GOVERNMENT OF THE DISTRICT OF COLUMBIA
DEPARTMENT OF TRANSPORTATION

MEMORANDUM

SUBJECT: BZA Case No. 19451 - 850 Delaware Ave SW - Ward 6 Emergency Shelter

Figure 1 - Site Access (Source: Gorove/Slade)

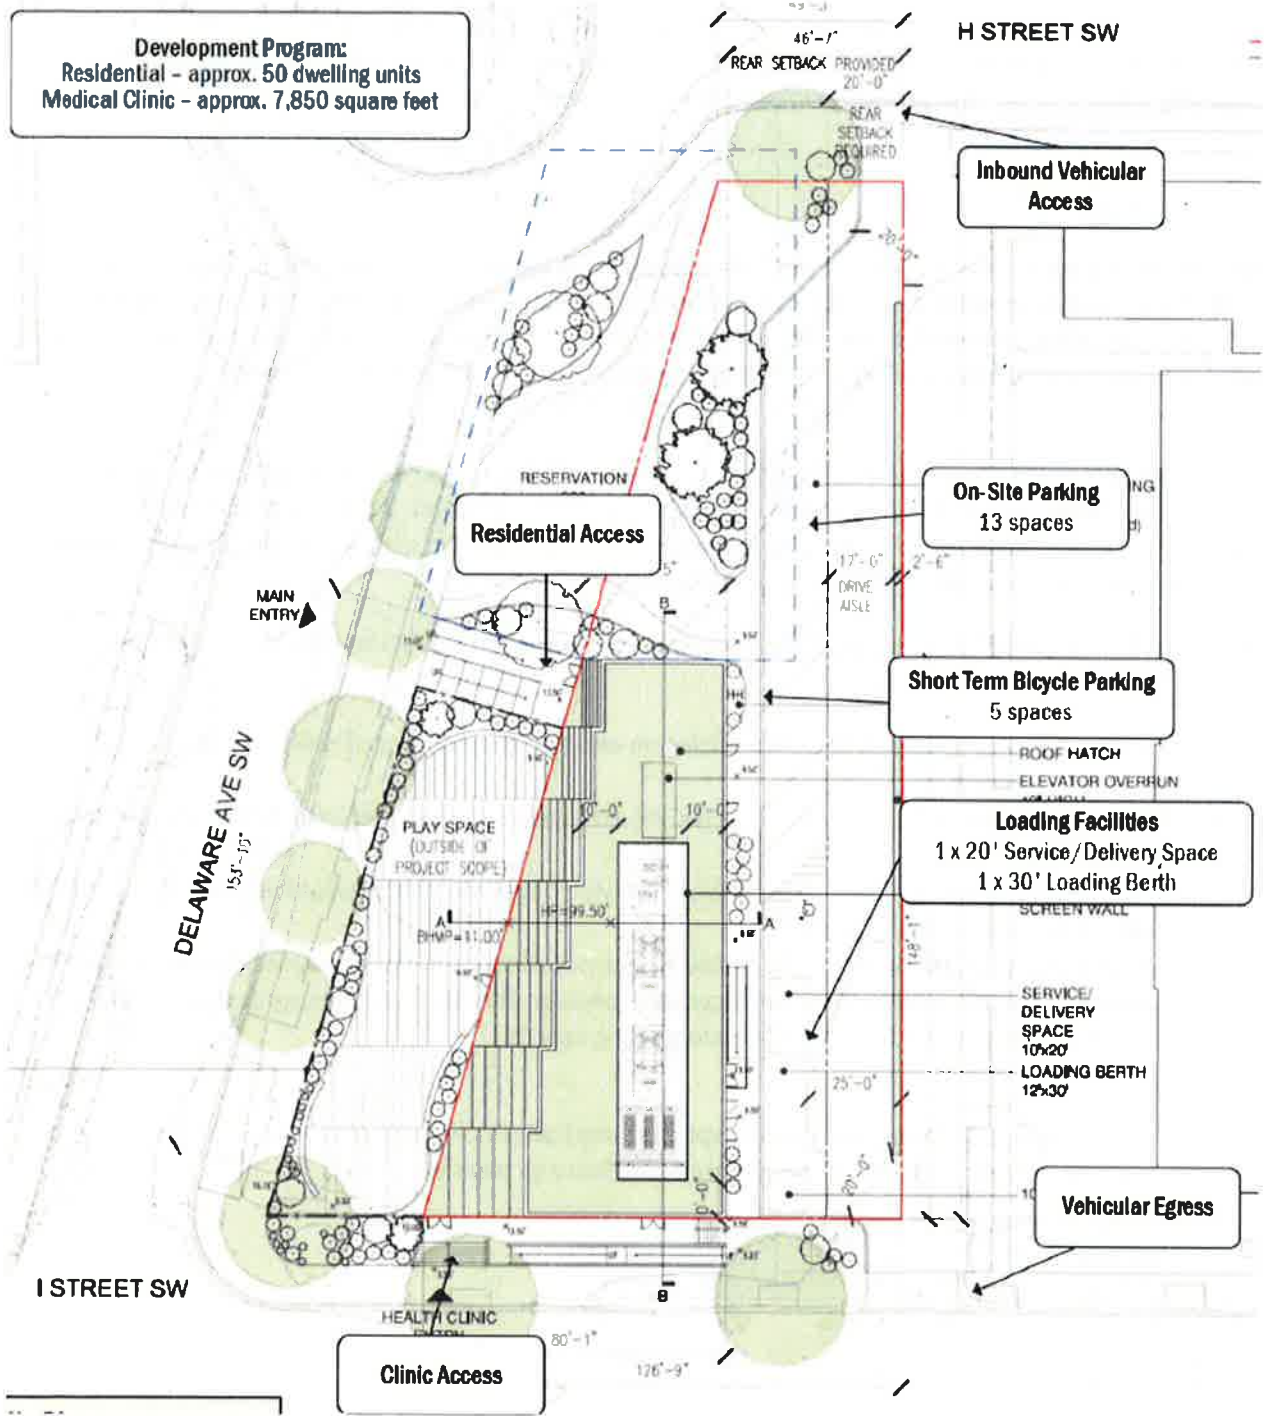
The site is located on an improved lot bounded by Delaware Avenue to the west, H Street to the north, a vacant commercial building to the east, and I Street to the south. A north-south private alley straddles the property line between the site and the vacant commercial building, with ingress from H Street and egress onto I Street. The Applicant proposes to utilize this alley for parking and loading access. The pedestrian access for the shelter is from Delaware Avenue via an accessible path to the main entrance, and the pedestrian access for the health care facility is from I Street.

Figure 3 - On-Street Parking Occupancy – 10 PM (Source: Gorove/Slade)

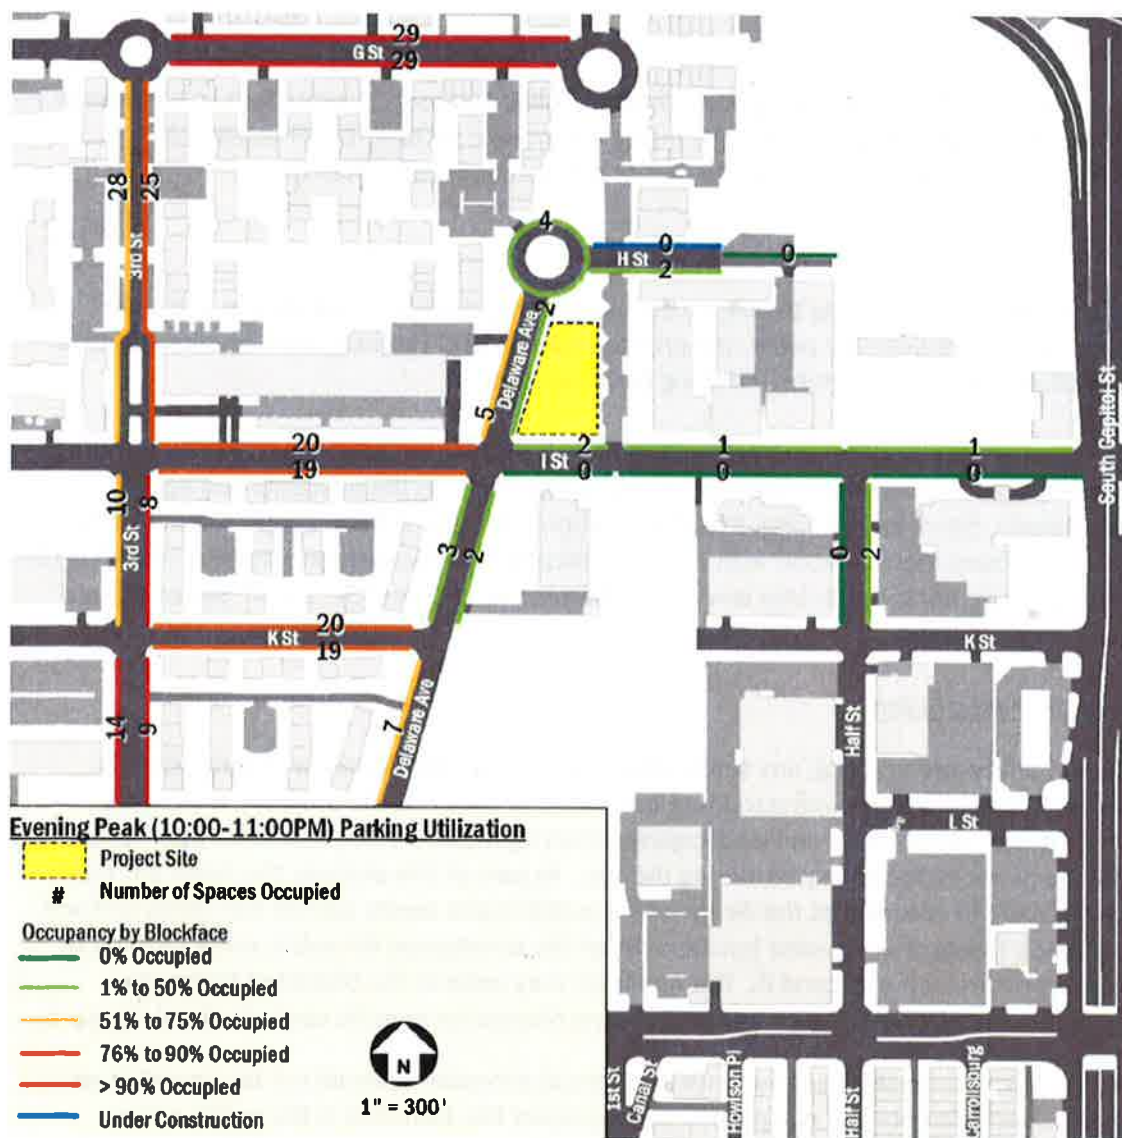
The Applicant performed a parking occupancy study on Tuesday, December 6, 2016, to determine if the surrounding street network has the capacity to meet parking demand. The study was conducted within a quarter-mile of the site, at hourly intervals from 5:00 pm to 12:00 am. The study shows that during 10:00 pm when peak occupancy was observed, there are approximately 156 available on-street parking spaces out of 344 spaces, excluding the private parking spaces on 3rd Street. The study concluded that the on-street parking supply has the capacity to meet parking demands generated by the staff use.
